**CITY OF MERIDIAN
FINDINGS OF FACT, CONCLUSIONS OF LAW
AND
DECISION & ORDER**

In the Matter of the Request for Conditional Use Permit for a Drive-through Establishment within 300-feet of Existing Residential Uses and a Residential Zoning District for Pine 43 West, Located at the Southwest Corner of N. Webb Ave. and E. Fairview Ave. in the C-G Zoning District, by CSHQA.

Case No(s). H-2024-0038

**For the Planning & Zoning Commission Hearing Date of: October 17 and November 7, 2024
(Findings on November 21, 2024)**

LANDSCAPE PLAN - AREA ONE
 Scale: 1" = 20'-0"
 23330/24006
 tEP Projects\2024\24006 Pine 43 West Retail - CSHOA\CAD\Sheets\24006_Landscape CUP.dwg, 11/14/2024 3:20:15 PM, DWG To PDF.pc3

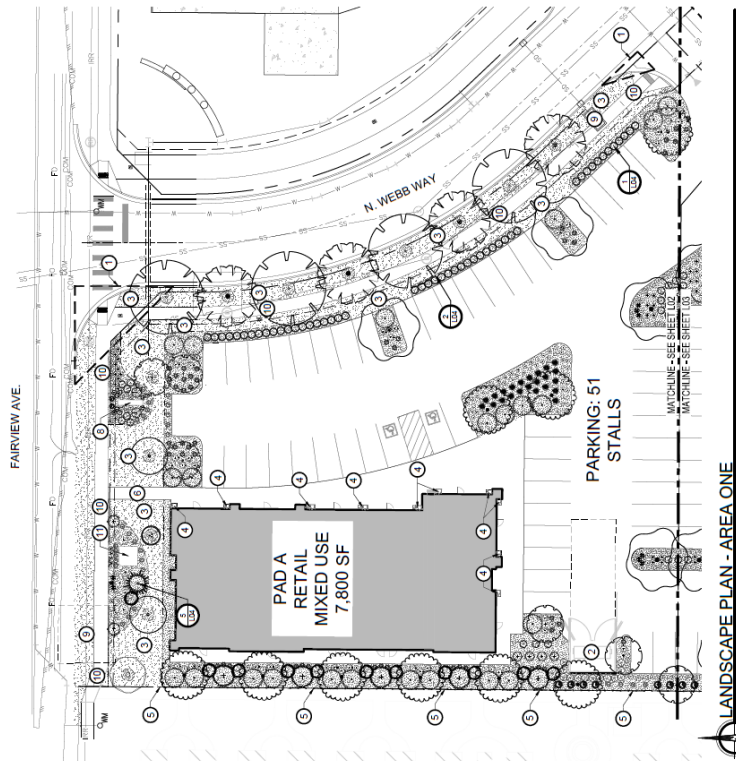
landscape plan should be revised to reflect 13 trees required within the street buffer along N. Webb Way, a collector street, and a minimum of nine (9) trees within the street buffer along E. Wilson St., a collector street; and a 20-foot wide street buffer required along E. Wilson St., a collector street. A revised landscape plan should be submitted that includes the additional trees and these revisions.

- j. Depict shrubs and other vegetative groundcover along with trees *within* the 20-foot wide buffer along N. Webb Way at the back side of the sidewalk in accord with UDC 11-3B-7C.3, instead of outside the buffer where vehicles will overhang beyond the parking spaces, which may result in damage to the shrubs/plantings.

- g. Depict a 5-foot wide detached sidewalk along E. Wilson St., a collector street, in accord with UDC 11-3A-17C.
 - ~~h. Correct the Project Information Landscape Requirements on the landscape plan to reflect 13 trees required within the street buffer along N. Webb Way, a collector street, and a minimum of nine (9) trees within the street buffer along E. Wilson St., a collector street; and a 20-foot wide street buffer required along E. Wilson St., a collector street. Note: The width of the driveway may be subtracted from the street frontage but the vision triangle and seepage bed/storm drainage areas should be included. Trees should be spaced in accord with the standards in UDC 11-3B-7C.4. Depicted on the revised landscape plan.~~

- ~~i. Depict a minimum of 13 trees within the street buffer along N. Webb Way and a minimum of nine (9) trees within the street buffer along E. Wilson St. in accord with UDC 11-3B-7C.3b. Where the street buffers are encumbered by easements that prohibit trees, the buffer area shall include a minimum five-foot wide area for planting shrubs and trees outside of the easement in accord with UDC 11-3B-7C.1b. Depicted on the revised landscape plan.~~
